Response to Review Comment

Name of the Student: **Rakesh Sinha**

Title of the Thesis: **Synthesis of Asymmetric Multiport Network**

Name of the Examiner: **Prof. Luca Perregrini**

Fig. 1: Return loss of asymmetric-T based BLC for port-4 excitation.

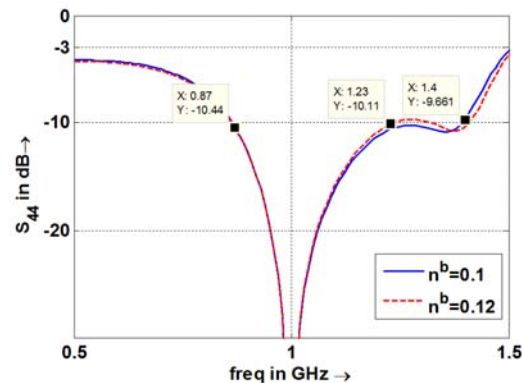
- 4) In Fig. 2.18 and 2.20 there are abrupt changes of the value of bandwidth. This phenomenon is highlighted in the text, however his physical origin and meaning is not discussed. This should be commented in the revised thesis.

Reply: The phenomenon of abrupt change of bandwidth in Fig. 2.18 and 2.20 have been explained in the revised thesis. The abrupt change in port-4 excitation matching bandwidth in Fig. 2.18 can be explained through the example shown in Fig. 1 below. Fig. 1 shows that S_{44} is just above -10 dB from 1.23 GHz to 1.31 GHz for $n^b = 0.12$, wherein S_{44} is just below -10 dB in that band of frequencies for $n^b = 0.1$. So the matching bandwidths are 34.28% and 46.70% for $n^b = 0.12$ and $n^b = 0.10$ respectively. This leads to sudden increase in the bandwidth around $n^b = 0.1$.
